## COASTAL STORM RISK MANAGEMENT PROJECT DRAFT INTEGRATED FEASIBILITY STUDY AND ENVIRONMENTAL ASSESSMENT

## **Value Engineering**

**Value Engineering Team Briefing**

**112339 ST. LUCIE COUNTY, FL**  
**COASTAL STORM RISK MANAGEMENT PROJECT**  
**DECISION DOCUMENT**  
**VALUE ENGINEERING REPORT**  
**31 December 2015**

Figure E-1: FWOP damages compared to Reach

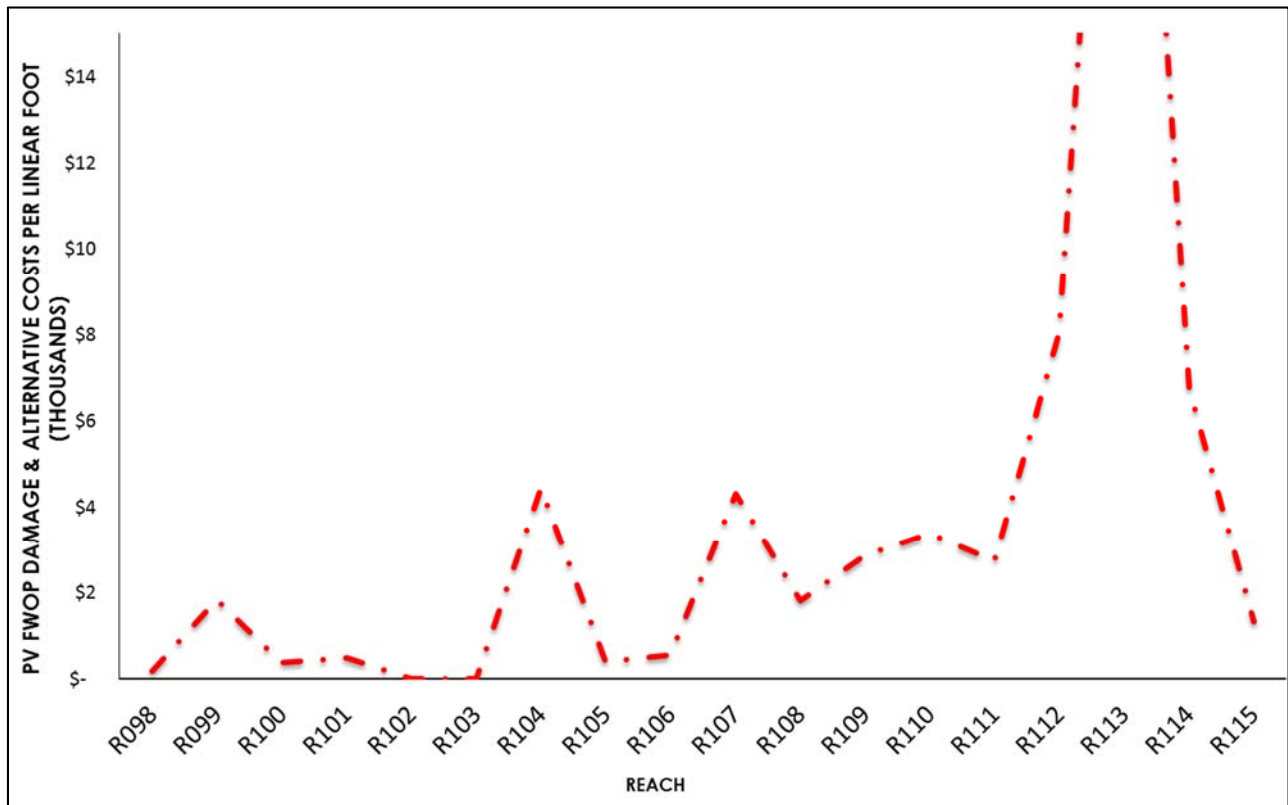
### RECOMMENDATION NO. 1 (2.0, 2.04, 2.05): Strategically Placed Breakwaters/Groins to Reduce Nourishment Cycle

**PROPOSED DESIGN:** This idea is to focus on the sub-reaches within the South Hutchinson Island reach which have the most damages (R111-R115, as shown in Figure E-1), in areas and place breakwaters, low-profile groins, or oblique groins to reduce wave energy and also trap sand.

This recommendation was not adopted by the PDT. The nourishment cycle could potentially be extended by the ability of these structures to trap sand in strategic areas. However, these structures have disadvantages which could be non-implementable.

Figure E-4: MHW Change Rate vs. DNR Monument 1970 to 2008

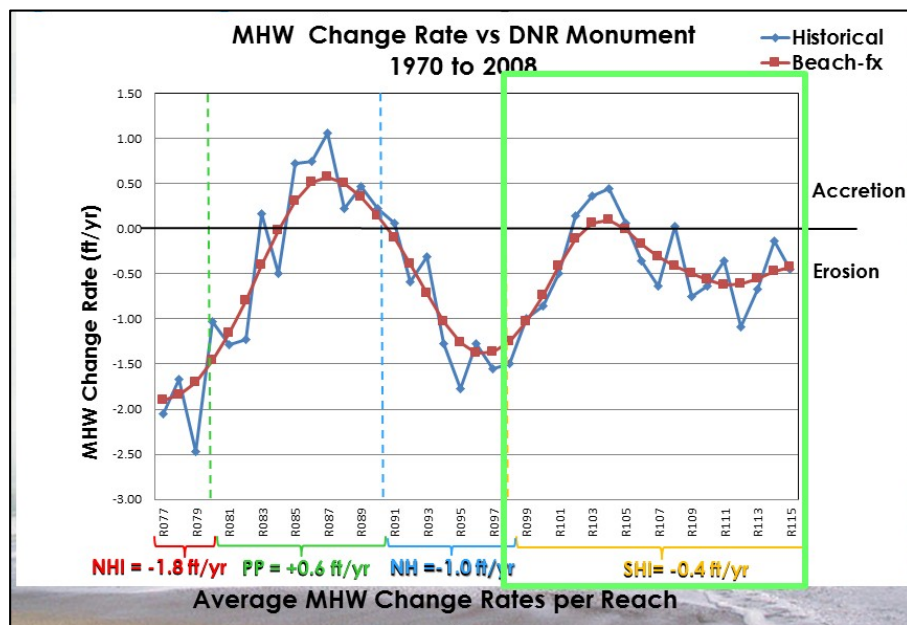
### RECOMMENDATION NO. 3 (7.0): Apply Erosion Measures Uniformly Across the Project Study Area

**PROPOSED RECOMMENDATION:** This idea is to apply erosion alternatives uniformly across the study area, due to the fact that erosion rates are fairly uniform. Accordingly to Figure E-4, erosion rates only vary by -1.8 to +0.6 feet per year in the entire study reach (R77 to R115 + 1000 feet), which is considered a small fluctuation. While there are areas of erosion and accretion there are no “hot spots” of high erosion that would need to be addressed with a specialized measure over a limited scale. Although the project has been de-scoped at this point to R98 to R115+1000 (the area shown in the green box), it is important to understand the reach as an entire system. Altering the natural forces in one area without a significant need could negatively impact adjacent shorelines.

This idea is important to convey in the Feasibility Report/Appendices and make the team aware of during continued plan formulation. Therefore, this recommendation was adopted by the PDT and will be presented in the Feasibility Report/Appendices.

Figure E-5: "Dune Stacking" - Rear and Fore Dune Concept

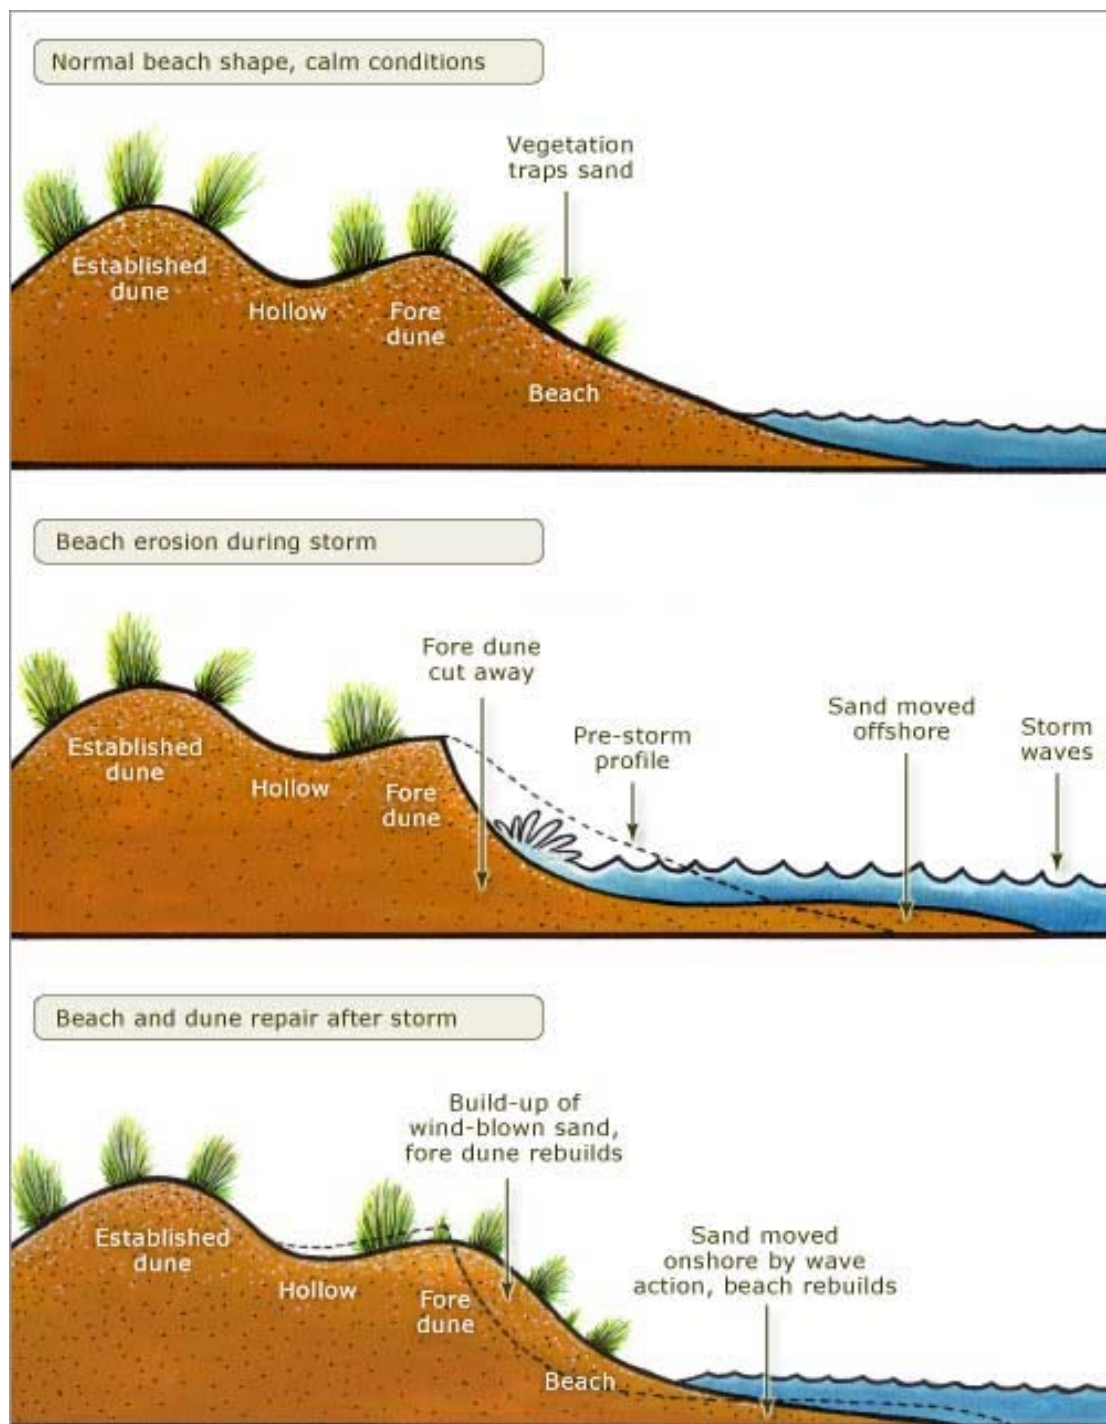
## **RECOMMENDATION NO. 5 (10.0, 10.11, 10.12): Options to Reinforce Dunes**

This idea is to consider options that relate to reinforcing dune features. See Figure E-5.

- a. Use sand fencing technique as a sand sink/dune stacking (fore dune/rear dune)
- b. Combination of small buried geotubes and dune stacking

This recommendation was not adopted by the PDT due to the disadvantages cited.

Figure E-6. Turtle Reef Club and Vistana Beach Club at R113 (slab on grade foundation)

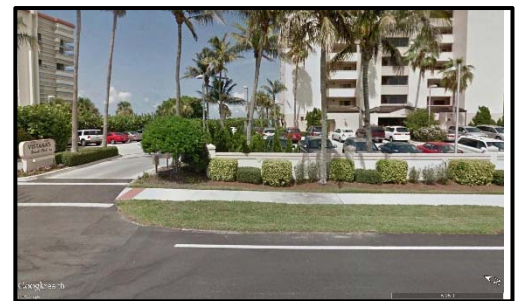
## **RECOMMENDATION NO. 6 (13.00, 13.25): *Strategic Buyout***

A strategic buyout idea would focus on the area “hot spots”, where damages would be most likely. In this case, two condominiums (Turtle Reef Club and Vistana’s Beach Club) are slab on grade construction, and are therefore more vulnerable to flood inundation damage than other condominiums on pile foundations (as currently shown in the future without-project damages in the Beach-fx model). Therefore, a buyout for all or some portion of these condominiums could potentially reduce the risk of flooding to the residents.

- a. One idea could be to buy out one or both condominiums.
- b. Another idea would be to buy out just the first few floors of each condominium, which would then have to be gutted and re-habilitated into empty space with piles, so that any flooding that occurred would not impact residents, residential space, or the structural integrity of the building.

This recommendation was not adopted by the PDT due to the disadvantages cited.

Figure E-7: Active Adaptive Management

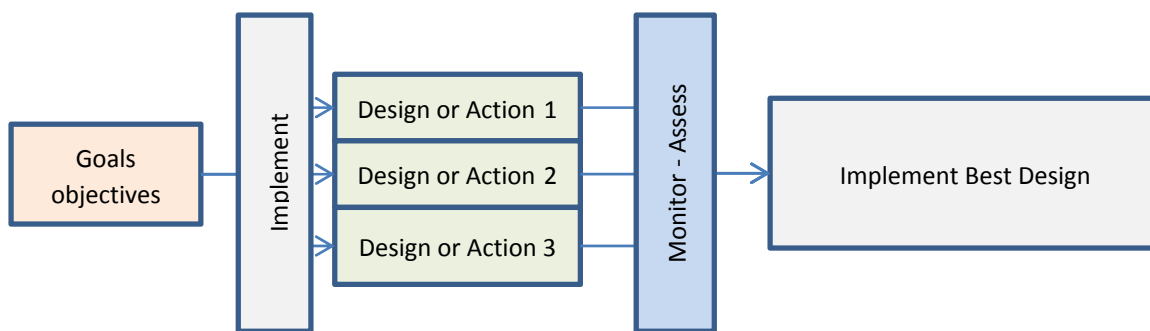
**Active Adaptive Management** (See Figure E-7) – Multiple pilot projects or design tests are implemented to test designs or operational criteria to achieve desired goals and objectives. Each design or operational action is monitored, assessed, and results are used to inform implementation of the best design for project component or operations. Pilot projects or design tests are usually conducted before implementing the full project component that they are intended to inform.

This recommendation was adopted by the PDT and will be presented in the Feasibility Report and further developed during PED phase.

Figure E-8: Passive Adaptive Management

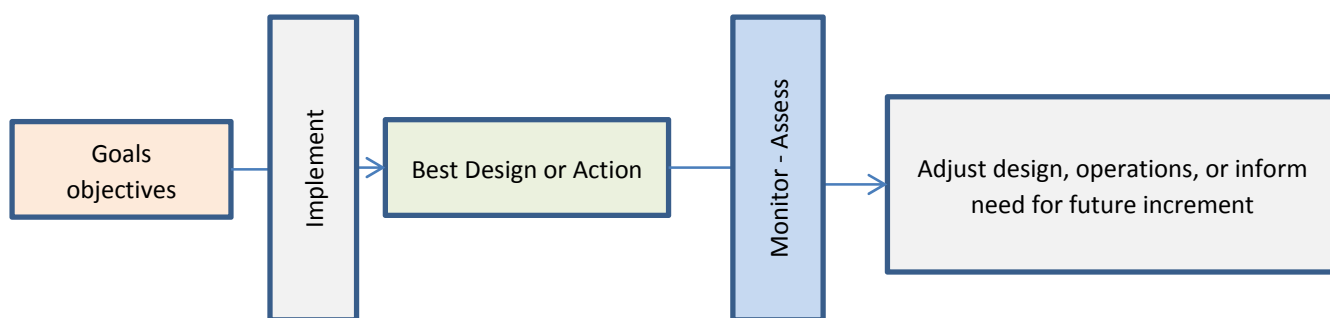
**Passive Adaptive Management** (See Figure E-8) – Most of the proposed St. Lucie County Adaptive Management Plan strategies are considered passive adaptive management approaches. One project component or set of operational criteria is implemented to test its ability to achieve desired goals and objectives. Results are monitored, assessed and communicated to implementing agencies and the appropriate participating agencies to determine how best to adjust project component designs, operations, contingency options, or inform future projects.

Figure E-10: St. Lucie Study Area in Coastal High Hazard Area Zone VE (FIRM MAP, Panel 0314, 2012)

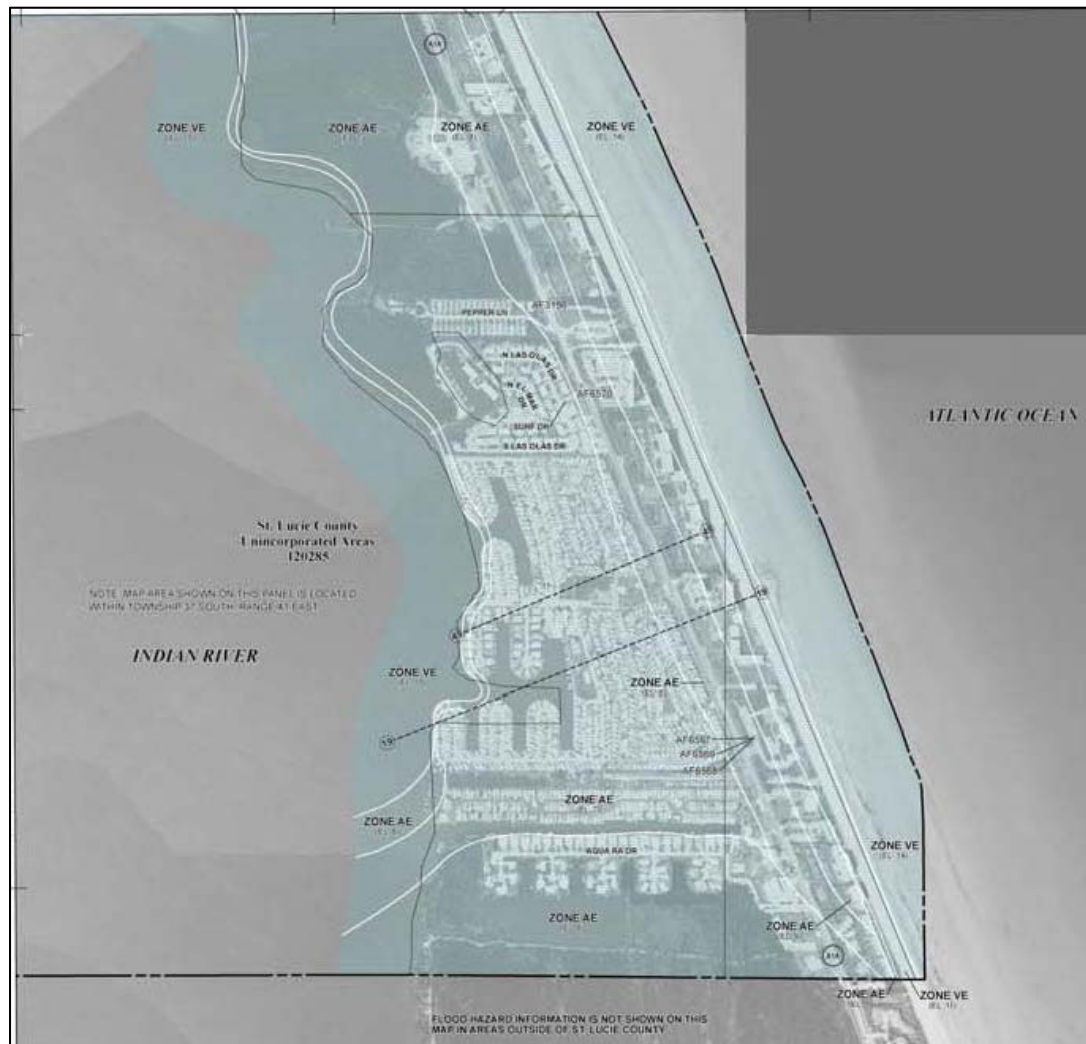
Flood shields (considered to be dry floodproofing) were the floodproofing measure most appropriate, since it would be cost prohibitive and structurally difficult to use wet floodproofing measures (ie: elevate the condominiums in the area). In general, the analysis found that per FEMA “Design Considerations for Floodproofing” and FEMA “ASCE 24 design standard” Section 6.2.1, dry floodproofing of buildings is not permitted in Coastal High Hazard Areas (Zone V), where the study area is classified as Zone VE (included within V), shown in Figure E-10. Therefore the alternative containing this measure was screened out and eliminated from further analysis.

During the VE workshop, the proposal was created to coordinate with the USACE National Floodproofing Committee. They would review the findings of the team on dry floodproofing, and provide feedback as to whether this alternative was rightfully ruled out, and any other floodproofing options that may exist.

This recommendation was adopted by the PDT and will be further developed during PED phase.
